**City of South Bend**  
**Council Meeting**  
**Monday, February 22, 2016 @ 5:30 pm**  
**Council Chambers**  
**1102 W. First Street, South Bend, WA**

## **RECOMMENDATION OF THE SOUTH BEND PLANNING COMMISSION PACIFIC SUNSET PRELIMINARY PLAT**

# PACIFIC SUNSET

Re: **Pacific Sunset Preliminary Plat**  
**Owner/Developer Comments on Gray & Osborne Review Comment Letter**  
JKA #1527

DRAWING TITLE:  
**PACIFIC SUNSET  
PRELIMINARY PLAT  
MAP**

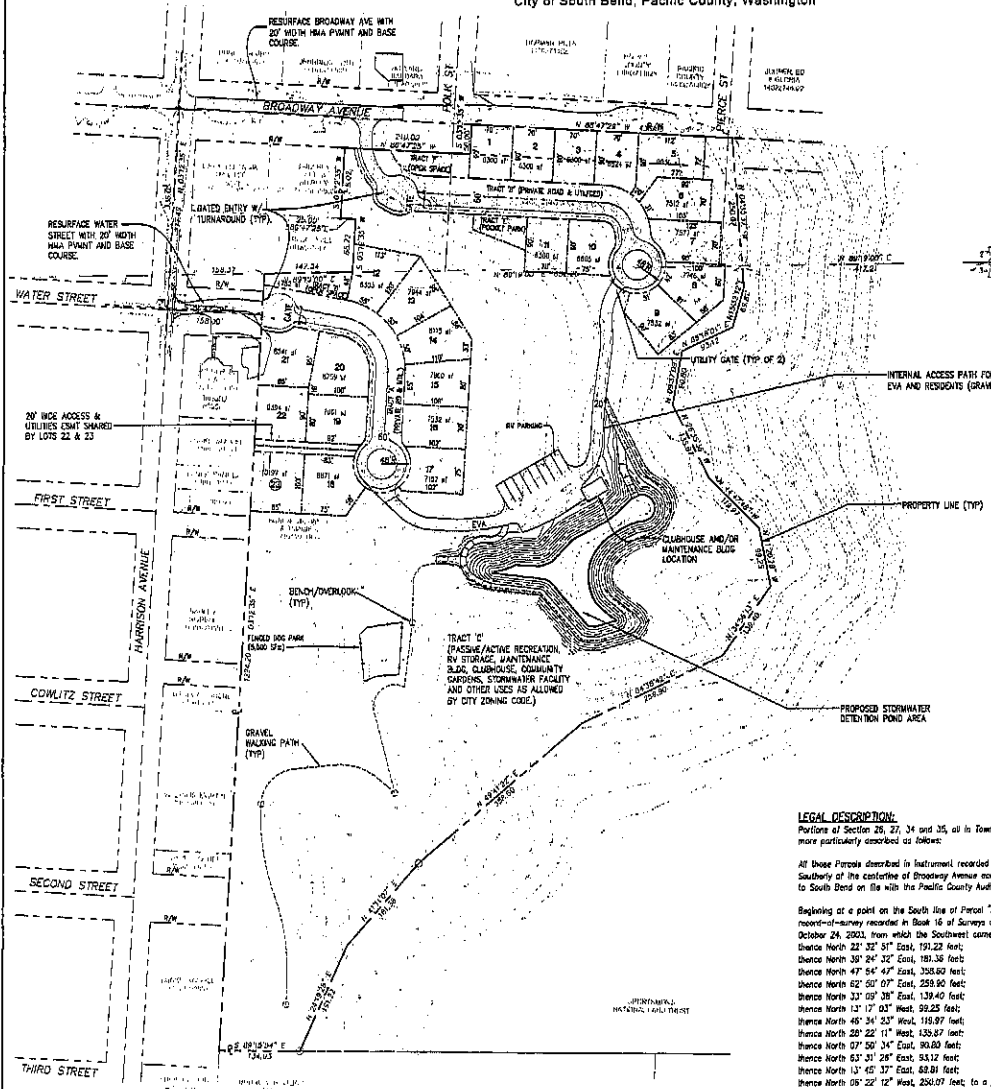
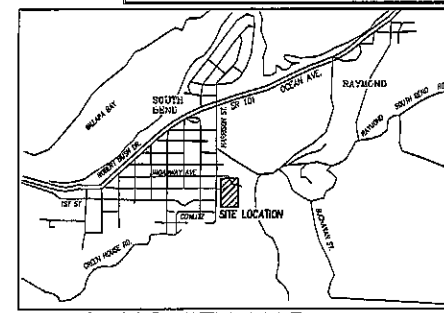
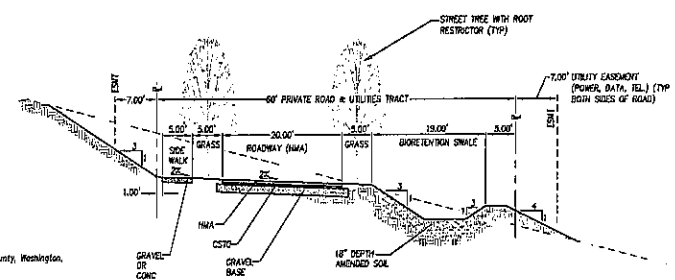
13. The tract Information provided on Sheet 1 shall be revised to indicate the proposed ownership and purpose of each tract. The tract areas shall be clearly delineated and labeled.
14. The locations of any proposed plat monument signs and the associated easements or tracts shall be shown and labeled. Monument signs shall be situated in a manner so as not to adversely affect safety or corner vision. The site triangles shall take in account the monument sign locations.
15. There shall be separate 15-foot easements provided to the City for sewer mains and for water mains. Other easements shall be provided for public utilities on residential lots abutting private roads or public rights-of-way. All existing and proposed easements shall be labeled and delineated on the final plat.
16. The area of each lot, in square feet, shall be stated on the site plan.

14. The Tract Information provided on Sheet 1 should be revised to indicate the proposed ownership and purpose of each tract. The tract areas should be clearly delineated and labeled.

16. The proposed flag lots (22 and 23) should be reviewed by the City Planner for consistency with City codes.
17. Any existing or proposed easements should be labeled and delineated.

18. The area of each lot, in square feet, should be stated on the site plan.
19. The building setback dimensions, demonstrating compliance with SBMC 16.60.030 yard requirements, should be labeled and delineated on the plans.
